RE: Twin Harbors, Lot 92A, Section 4
201 Nomini Drive
Arnold, MD 21012
TM 32E BLK 24 P 426, R-2 Zoning, Council District 5

On behalf of the property owner, M.A.F and Associates, LLC is submitting a variance application for the above-mentioned project. The property owner is proposing to submit a variance application to allow disturbance within slopes greater than 15% in the Critical Area as well as the associated buffer. This request is being made to allow for the demolition and construction of a wood deck, 2 sets of steps to grade and a pool. This new deck and pool will be constructed in a similar location to the existing wood deck and pool. Because we are required to show a minimum amount of perimeter disturbance, the plan shows impacts to steep slopes and the 25' steep slope buffer. This proposal will require a variance to allow development within slopes greater than 15% in the Critical Area as well as the associated buffer. The proposed wood deck and pool will be the same height as the existing wood deck and pool. The proposed wood deck is irregular in shape with an overall footprint similar to the existing wood deck and is setback as close as 45.13' from the northern front pro

PROPOSED DECK AND POOL LAYOUT

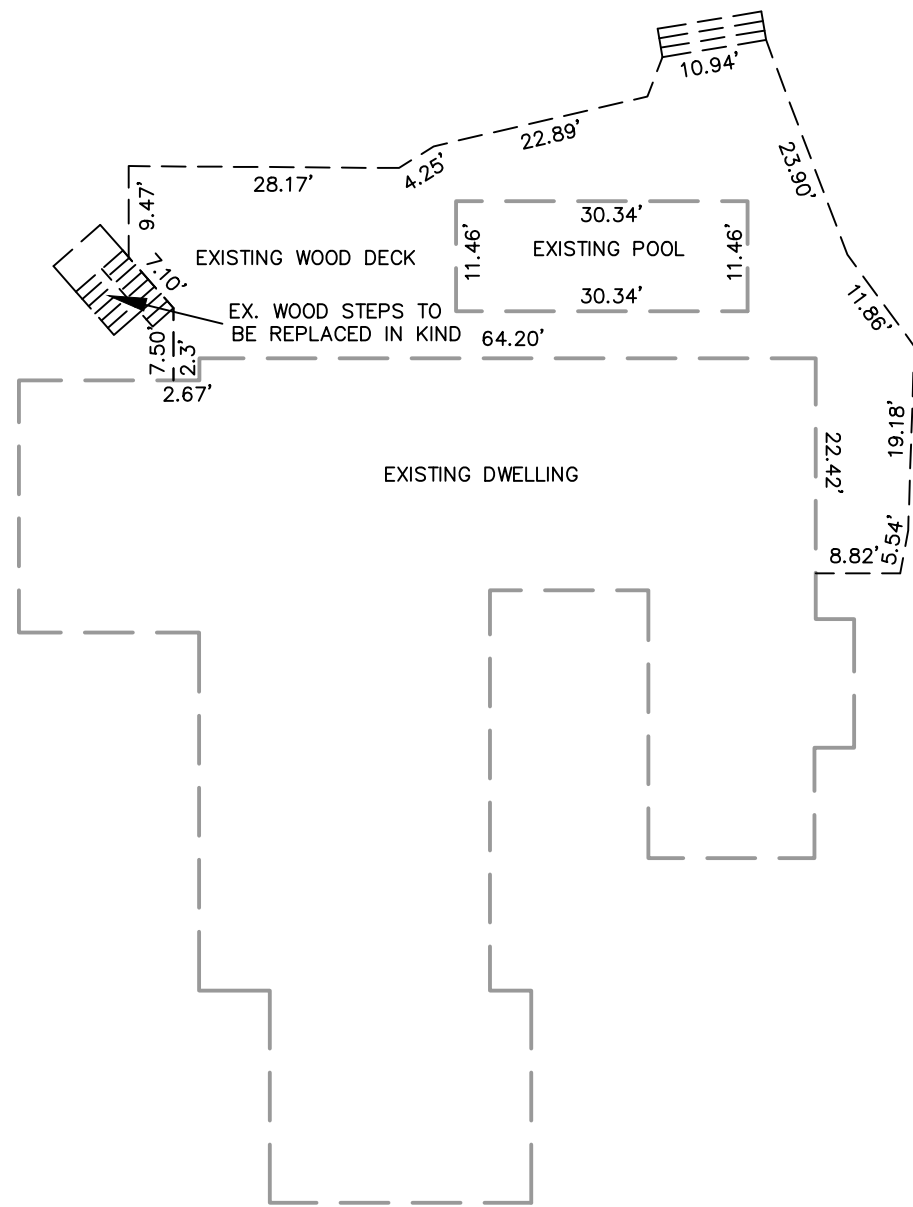
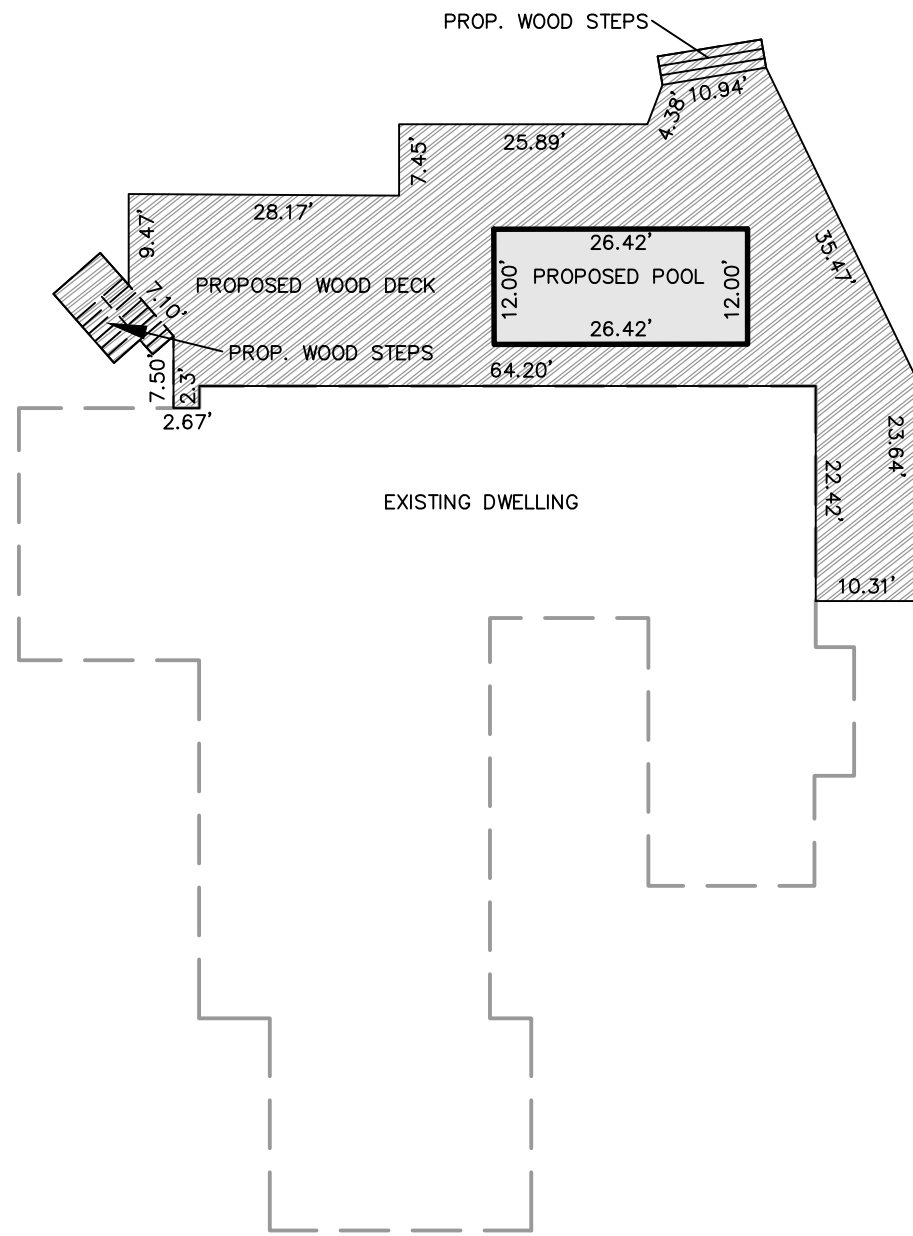
Critical Area Team: There is no objection to the repair/replacement of the existing deck and pool however cannot support the expansion of any of the proposed dimensions for the replacement.

The 10% lot coverage reduction requirement will be addressed at permit. The calculations depicted on this plan do not reflect compliance. Approval will not be granted until this requirement has been addressed.

Zoning Administration Section: This proposal cannot be considered the minimum required given that a replacement in kind is possible without actual disturbance to steep slopes.

Our response: The small expansion of the deck is for safety purposes. The existing deck has some odd angle down the side of the house that makes pedestrian traffic difficult and a bit unsafe. Likewise, the small expansion on the waterfront side of the pool is for the same safety reason. The existing deck is angles close to the corner of the existing pool that makes it unsafe to walk around the pool in this location. The new configuration makes the pool a little smaller than the existing pool as well as makes the area much safer to walk around being so close to the top of slope.

Our response: The plan has been revised to reflect the 10% lot coverage reduction requirement. This required the limit of disturbance to be adjusted and therefore the variance request has been slightly adjusted.

Our response: The small expansion of the deck is for safety purposes. The existing deck has some odd angle down the side of the house that makes pedestrian traffic difficult and a bit unsafe. Likewise, the small expansion on the waterfront side of the pool is for the same safety reason. The existing deck is angles close to the corner of the existing pool that makes it unsafe to walk around the pool in this location. The new configuration makes the pool a little smaller than the existing pool as well as making the area much safer to walk around being so close to the top of slope. We feel with the safety issues considered and the reduction in pool size, this plan demonstrates minimum relief and feel this request should be supported.
